ONSITE SEPTIC City of Portland – Bureau of Development Services
1900 SW 4th Avenue, Portland, Oregon 97201 – 503-823-6892 – TTY 503-823-6868 – www.portlandoregon.gov/bds
SEPTIC REVIEW CERTIFICATION (Land Use/Planning)

Address of Proposed Work: 12460 NW SPRINGVILLE RD
Property Map & Tax Lot #: 1N.1W.16D 2800 Alternate Acct #: R _____
Description of proposed work for this Septic Planning Review NEW INSTALLATION PERMIT
New SFR 10 BR home
Change in number of bedrooms? Yes No # of existing bedrooms _____ # of bedrooms at completion 10
Applicant's Name SCOTT REED
Applicant E-mail SCOTT@REEDREALTYGROUP.COM
Mailing Address 1381 NW BENFIELD DR, Phone _____
City PORTLAND State OR ZIP 97229

17-198976 SE

Scott Reed Residence
T1N, R1W, Sec16D, TL 3100&2800, Sec15C, TL600
Site Plan

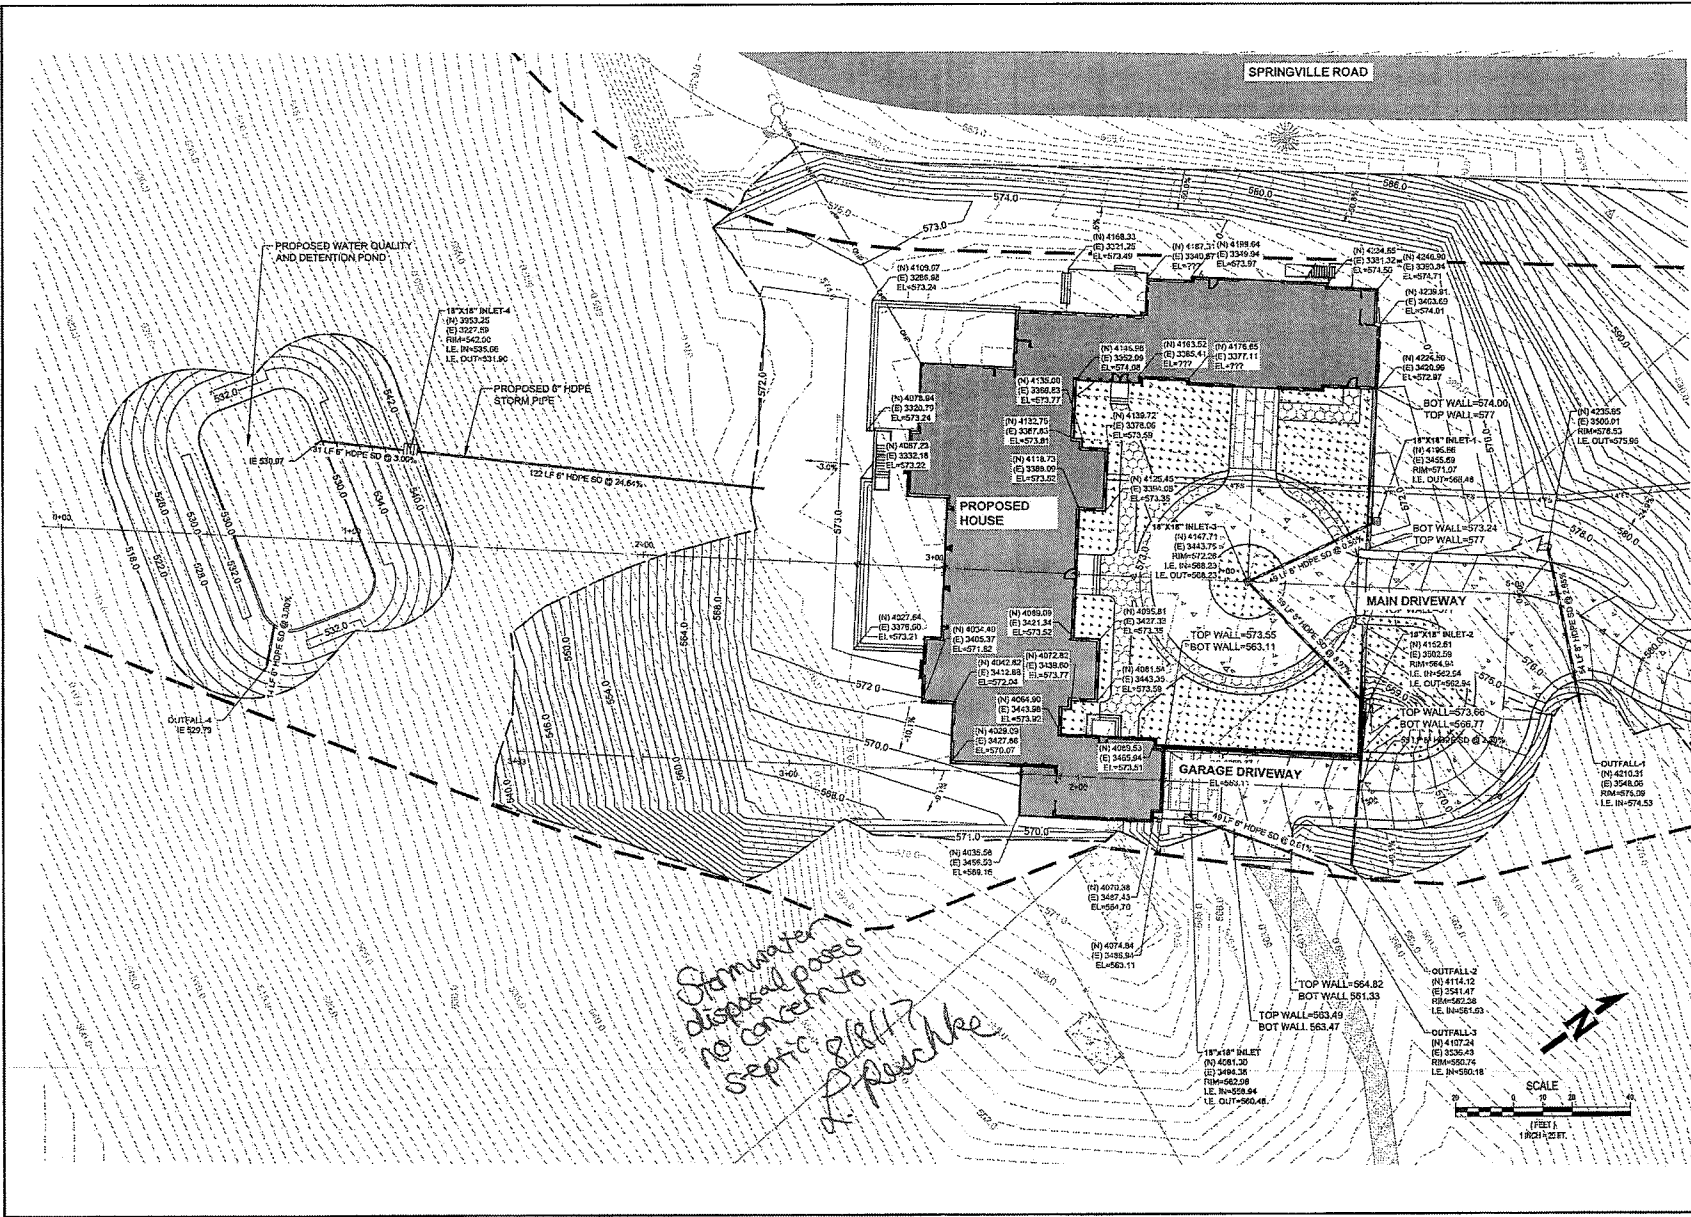
*Proposed OBR
NISR poses no
concern to
septic
8/8/17
A. Pouchka*
